The Cryosphere Discuss., referee comment RC1 https://doi.org/10.5194/tc-2022-132-RC1, 2022 © Author(s) 2022. This work is distributed under the Creative Commons Attribution 4.0 License.

Comment on tc-2022-132

Referee comment on "Ice thickness and water level estimation for ice-covered lakes with satellite altimetry waveforms and backscattering coefficients" by Xingdong Li et al., The Cryosphere Discuss., https://doi.org/10.5194/tc-2022-132-RC1, 2022

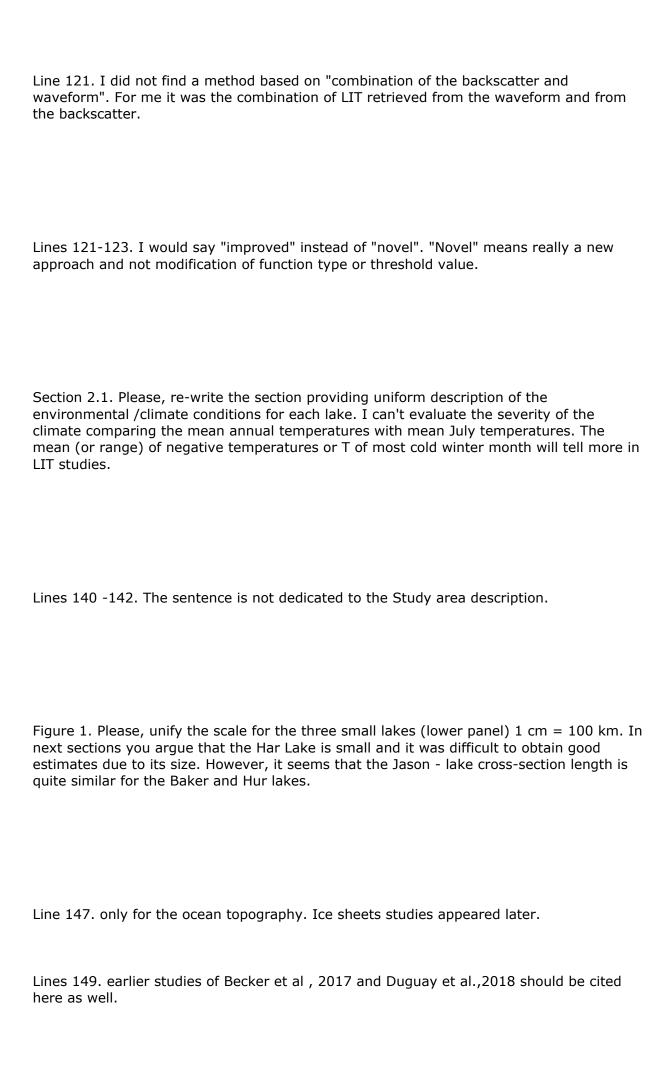
The supplementary material provides an excessive theoretical information and can be reduced to several lines describing how exactly the inter-satellite bias was calculated (along-track point-by-point approach or on the cycle basis, the length of the tandem mission phase for each tandem, and the obtained bias for each tandem - average or median bias plus the standard deviation or the range. This information is crucial for evaluation of the results. The authors claims several times in the texts that the presented method does not take the in situ observations, while in the Methods section the calibration of several parameters of equations was mentioned. More information on this calibration is required (period of calibration, values of calibrated parameters, uncertainties).
